Union Station Parking Garage Fire Alarm Upgrades

Addendum Number 1: Issue Date: March 02, 2026

- *2026-02-11 USPG Cutting Coring, Drilling & Anchoring Requirements*
- *Revised Fire Alarm Drawings Sheet FA2.02S-3 - FIRE ALARM-BUS LEVEL-NEW WORK-SOUTH*
- *Revised Fire Alarm Drawings Sheet FA5.00-3 - FIRE ALARM-RISER DIAGRAM*
- *Updated Specifications 26 05 33 Raceways and Boxes*
- *Updated Specifications 28 30 01 Fire Management System - Low Rise*

FA2.02S-3

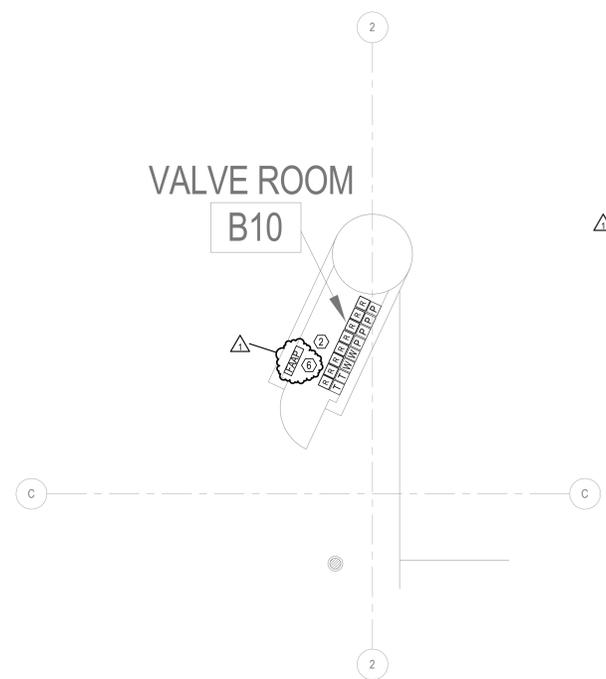
- **Bid-RFI 13**
Roof-mounted valve rooms contain notification appliances. Any existing notification appliances shall be removed and replaced with new.

- #### SHEET NOTES
- PROVISION OF (3) HORNSTROBE COMBINATION DEVICES. FIELD COORDINATE MOUNTING LOCATIONS PER EXISTING SPACE LAYOUT.
 - REFER TO DETAIL#3 ON SHEET FA7-00-3 FOR ADDITIONAL INFORMATION.
 - REFER TO DETAIL#5 ON SHEET FA7-00-3 FOR MOUNTING HEIGHT.
 - INTERFACE EXISTING ESCALATORS WITH NEW FIRE ALARM SYSTEM. REPLACE ALL EXISTING FIRE ALARM DEVICES WITH NEW. COORDINATE WITH ESCALATOR CONTRACTOR TO PROVIDE ALL REQUIRED INTERFACE MODULES, WIRING, AND CONDUITS. REFER TO SHEET FA0-00-3 FOR MORE DETAILS ON SCOPE OF WORK.
 - FIELD COORDINATE MOUNTING LOCATIONS PER EXISTING SPACE LAYOUT.
 - EXISTING FIRE ALARM REMOTE ANNUNCIATOR PANEL IN VALVE ROOM B10 ONLY. REPLACE THE REMOTE ANNUNCIATOR PANEL AND ASSOCIATED WIRING AND CONDUIT WITH NEW.

TITLE
FIRE ALARM - RISER DIAGRAM

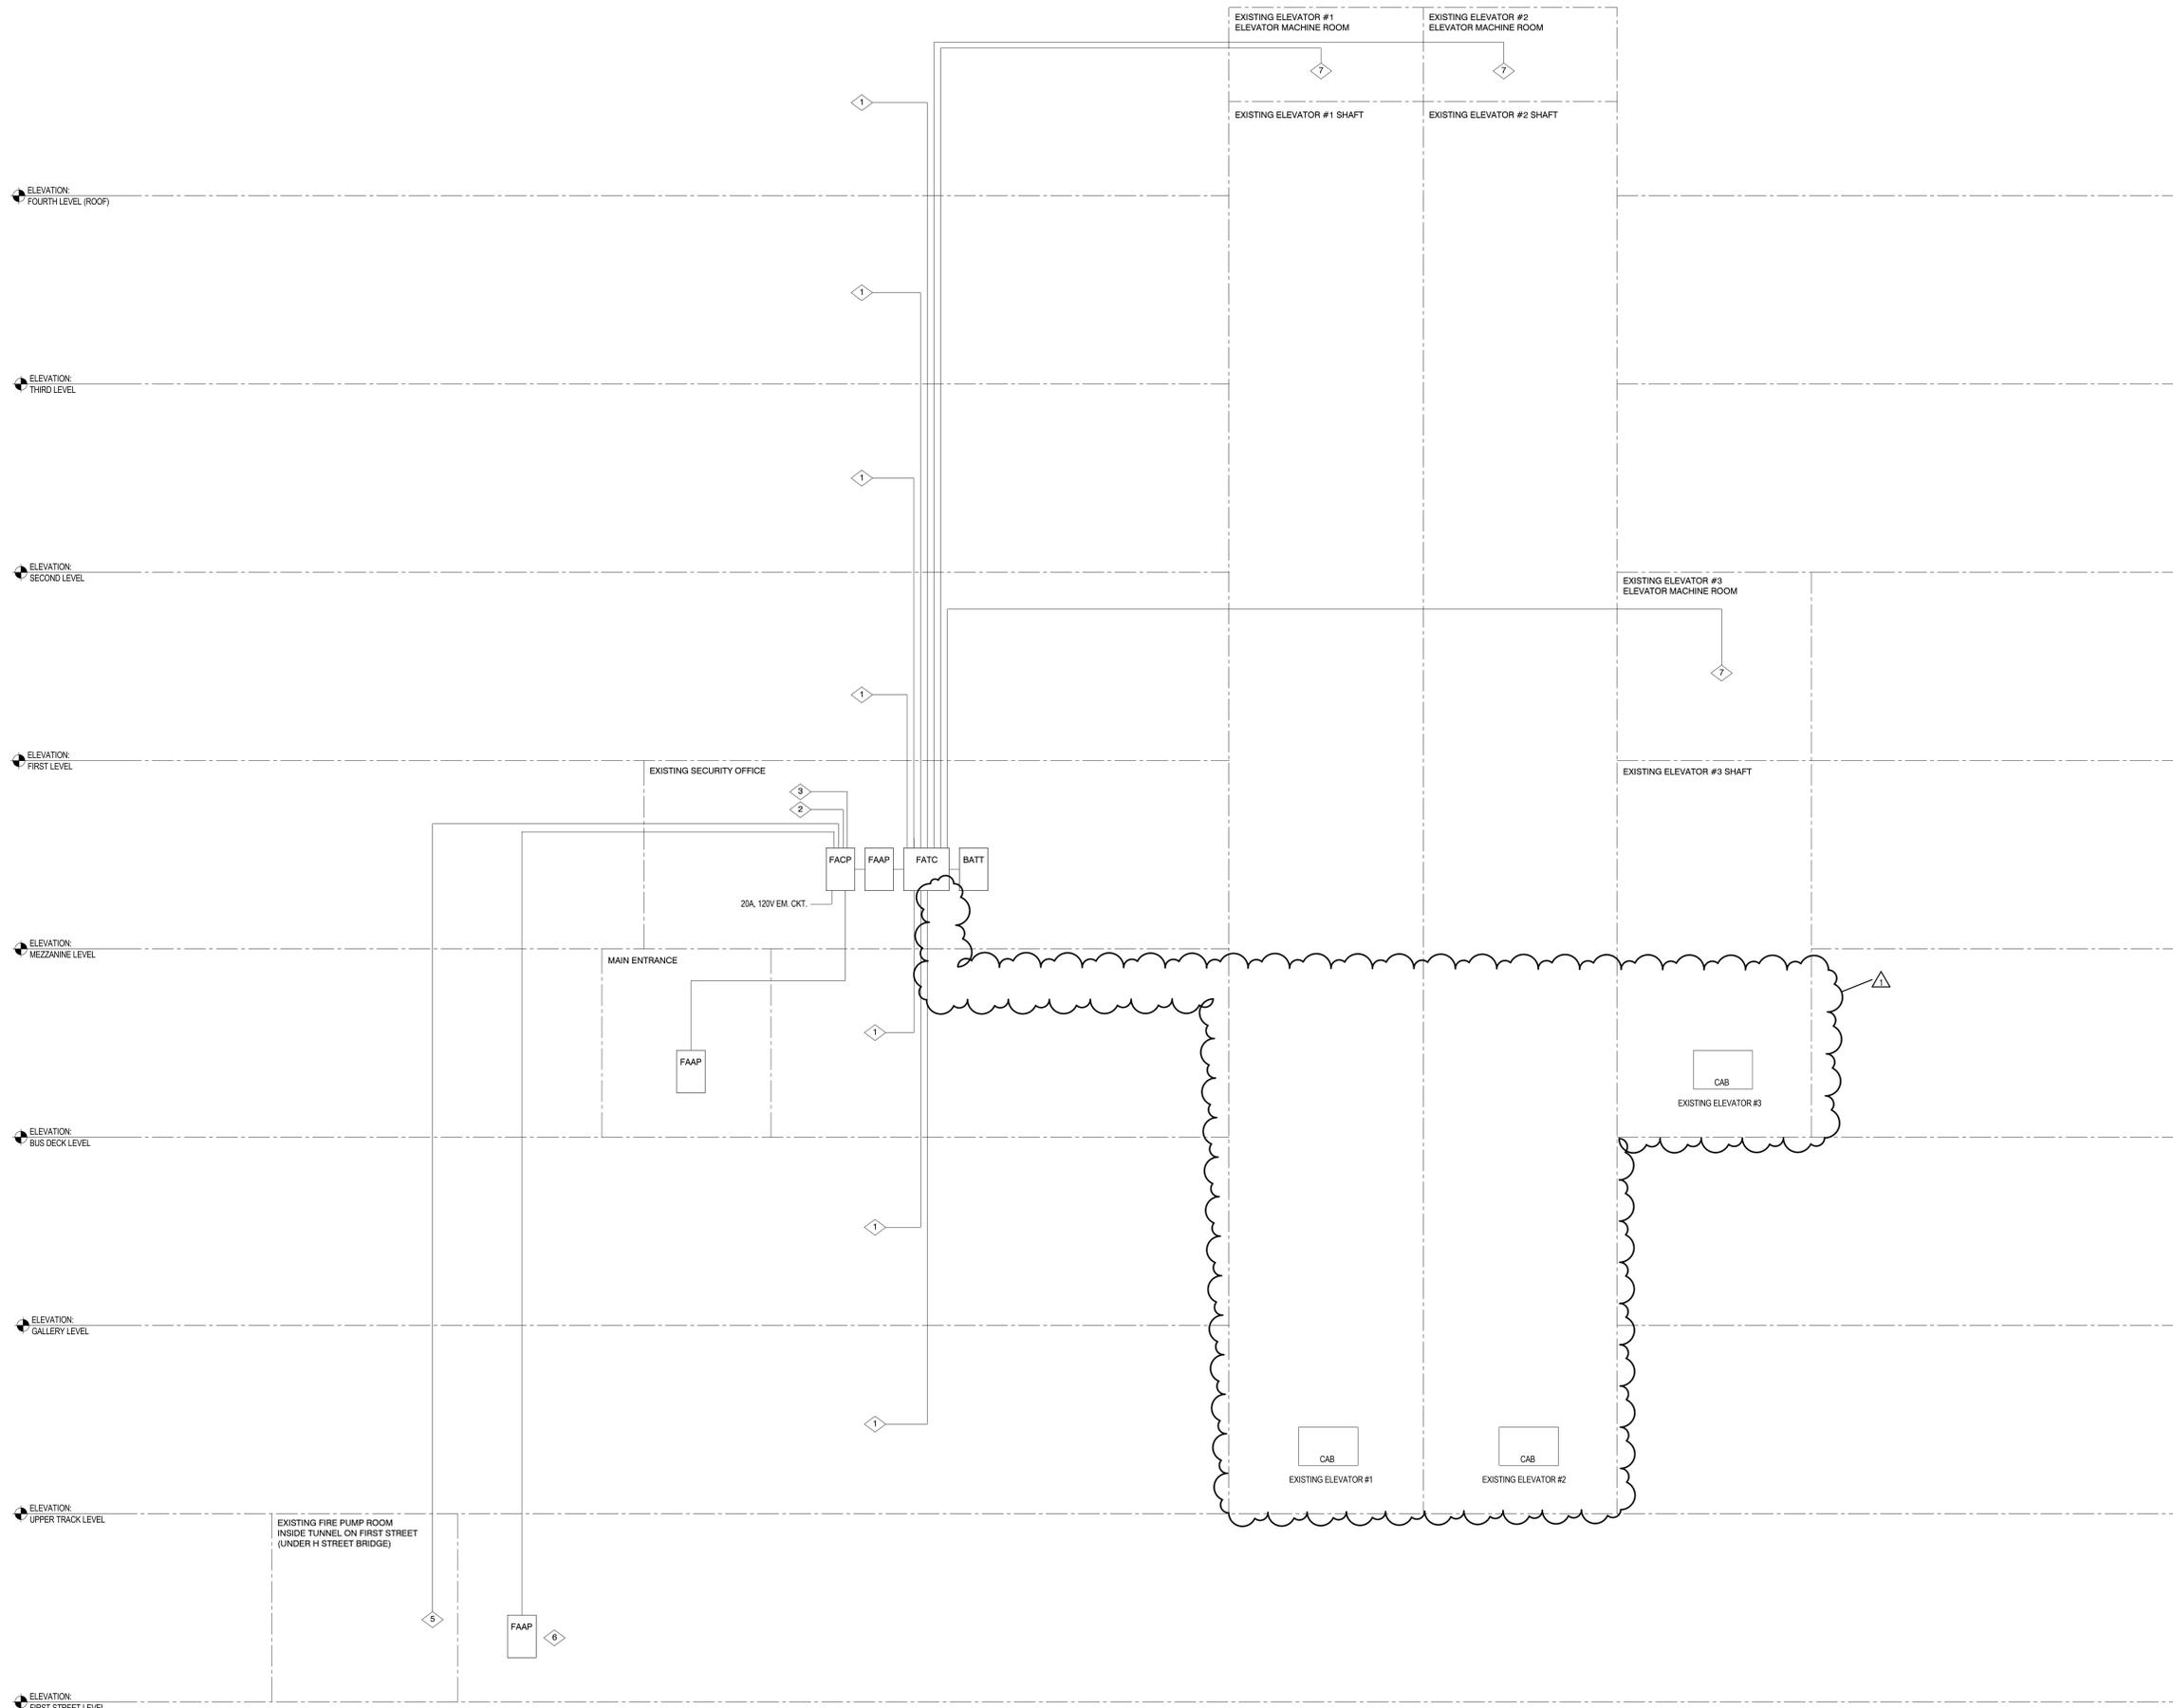
- **Bid-RFI 01:**
Communication devices in elevator cabs are existing, and to remain. No work in the elevators cabs is required. No fire alarm speaker coverage for voice evacuation is required throughout the garages including elevator cabs. Horn/strobe shall be provided per fire alarm drawings. Upon further review, the 2" empty conduits between FACP and elevator shafts per Keynote #4 on sheet FA5.00-3 are not required.

- **Bid-RFI 04:**
Provide a 1" conduit with pull string between FACP communication modem and telephone interface backboard. A 3/4" conduit is acceptable based on accommodating the required cable quantity. Allow 150 LF. A 3/4" conduit is acceptable based on accommodating the required cable quantity.

- **Bid-RFI 14**
Provide a 1" conduit with pull string from the FACP to the security control panel for future integration. A ¾" conduit is acceptable based on accommodating the required cable quantity.

- 1 REFER TO FLOOR PLAN FOR ACTUAL LOCATIONS OF ALL DEVICES.
- 2 PROVIDE A 1-INCH EMPTY CONDUIT WITH PULL STRING FROM THE FACP TO THE NEAREST TELECOM TERMINAL BACKBOARD. CONNECT THE FIRE ALARM CONTROL PANEL COMMUNICATIONS MODEM TO DEDICATED TELEPHONE LINES PER THE REQUIREMENTS OF THE AHJ.
- 3 PROVIDE A 1-INCH EMPTY CONDUIT FROM THE FACP TO THE SECURITY SYSTEM CONTROL PANEL.
- 4 (ELETED)
- 5 REFER TO DETAIL 4 ON SHEET FA4.00-3 FOR SCOPE OF WORK ON REPLACEMENT OF EXISTING FIRE ALARM DEVICES ASSOCIATED WITH EXISTING FIRE PUMP ROOM.
- 6 FAAP TO BE LOCATED ADJACENT TO EXISTING WET PIPE FIRE DEPARTMENT CONNECTION (FDC).
- 7 REFER TO SHEET FA0.00-3 FOR SCOPE OF WORK ON FIRE ALARM INTERFACE WITH EXISTING ELEVATOR.
